PLAN AND ZONING COMMISSION

REPORT TO PLAN AND ZONING COMMISSION Meeting Date – October 4, 2016

REQUESTED ACTION: A conditional use to permit establishment of a 12,660 SF “shopping center” in the Commercial Core area of Mahomet on a ~32,600 SF parcel. The development as proposed is a conditional use in the C-2 General Commercial Zoning District.

OVERALL SITE PLAN
NEW RETAIL BUILDING
602 E. MAIN ST.
MAHOMET, ILLINOIS

PROJECT: 13-1601
DESIGN BY: BKB
DRAWN BY: BKB
DATE: 8/20/16
SHEET:

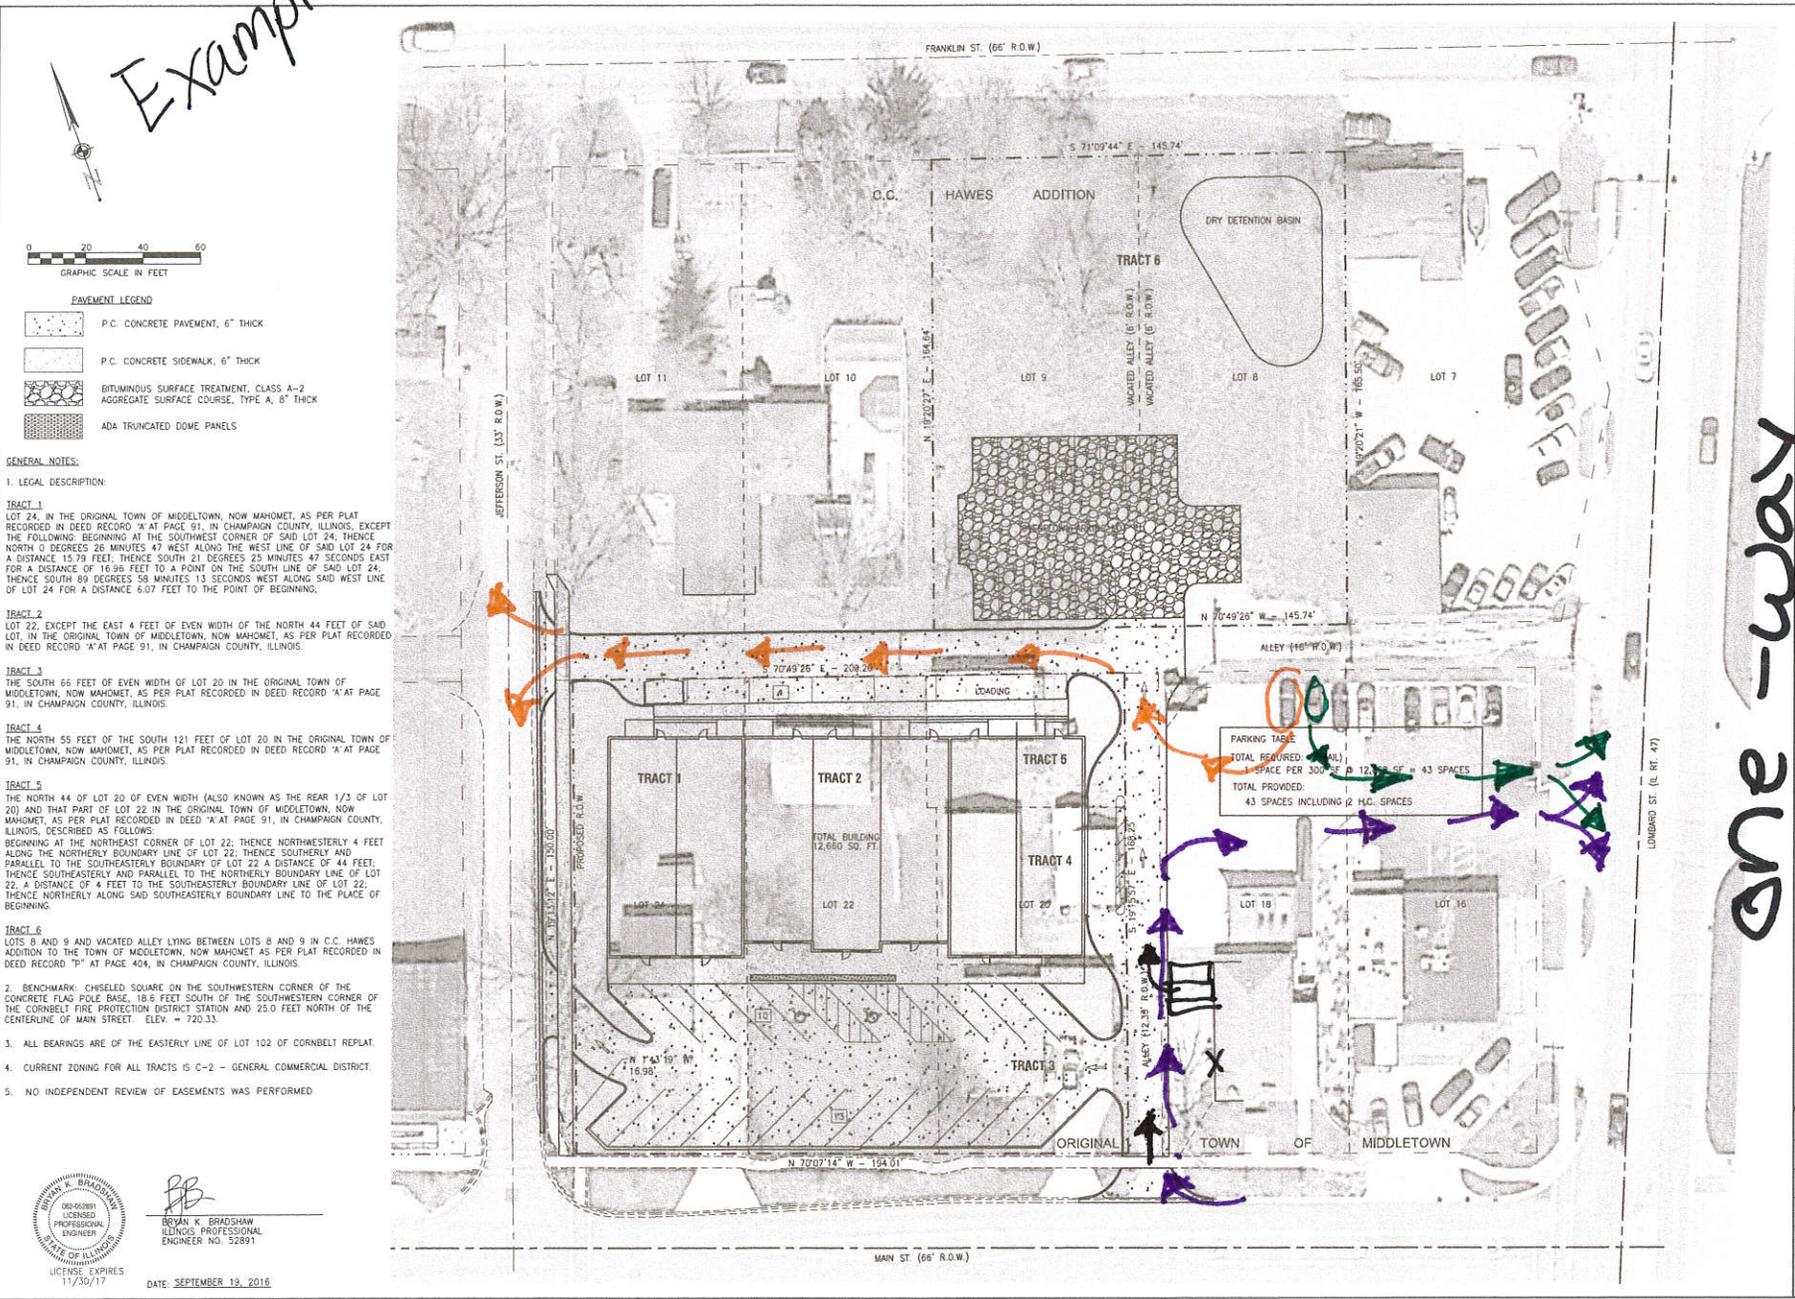
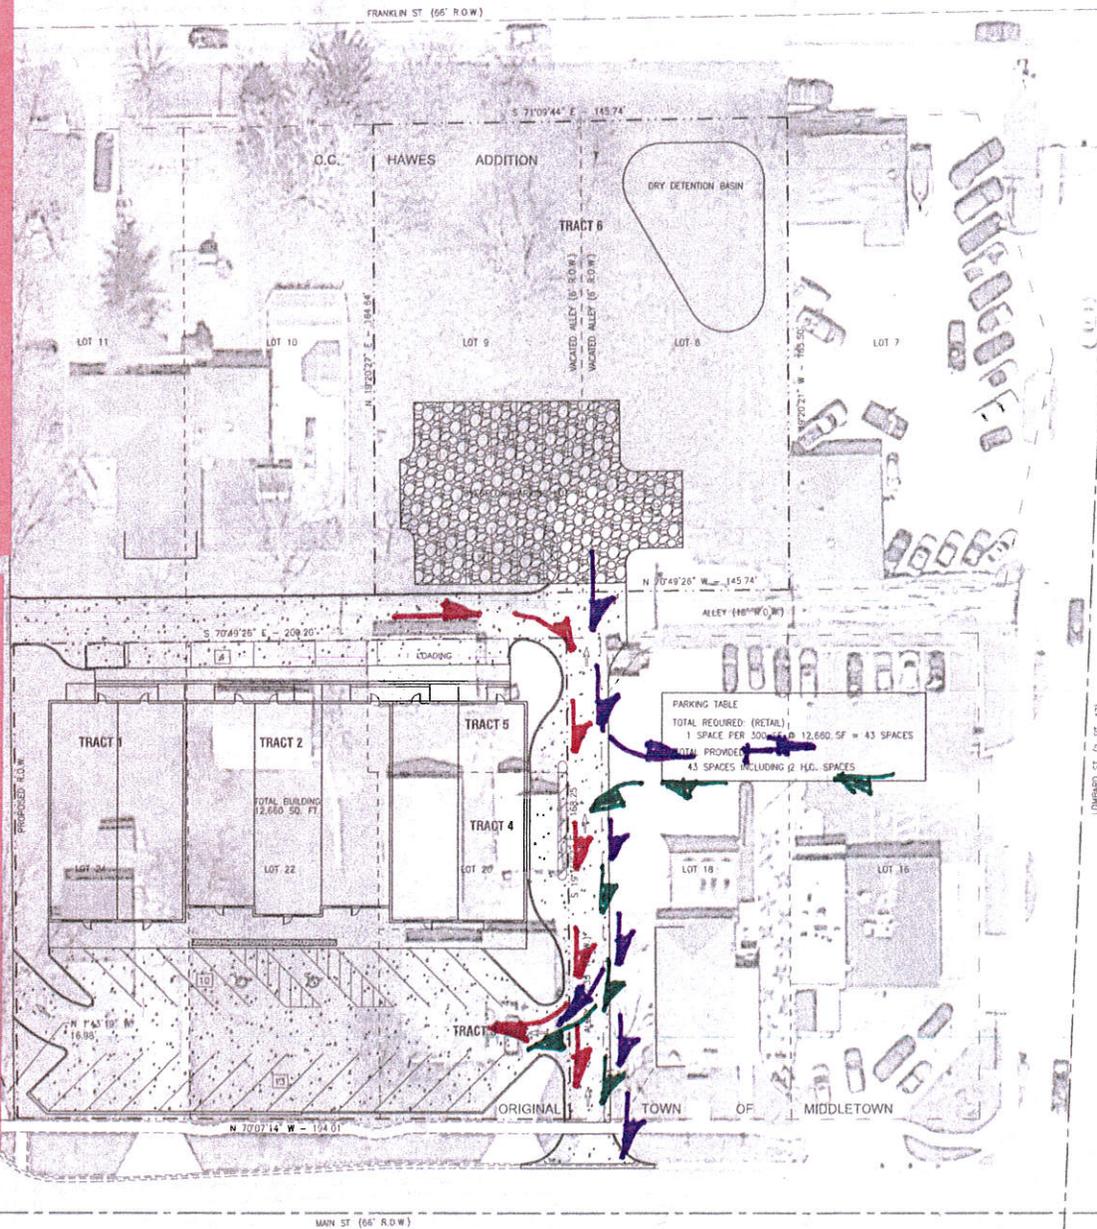
See attachments for examples and options related to vehicles entering and those exiting from various areas to various destinations. The exhibits show the effect of the proposed one-way and indicate the effect if the alley on the east side of the property was two-way.

So off-site parking lot vehicles will exit the site onto Jefferson and proceed left to get to Main Street. This is a challenging intersection. If the destination is Lombard, the vehicle has to turn right onto Jefferson and right again onto Franklin to get to Lombard. Fortunately the Lombard / Franklin intersection includes a traffic signal. If the alley were two-way, a vehicle could exit the site via the Wingery lot to Lombard or travel directly south on the alley to Main Street. Three (3) possible exits are added for the off-site lot if the alley is two way.

7. **Wingery and Taffie's lot exiting change.** Traffic from these sites would no longer have the ability to exit onto Main St.. The vehicles would have to exit directly onto Lombard or get to Main St. by traveling west along the alley to Jefferson St. This is a very out of the way method of exit and likely most people won't prefer this option. Nor do staff see a method of pavement marking and areas for signage that could assure vehicles do not turn left when reaching the north / south alley and traveling south as they have been able to do for years.
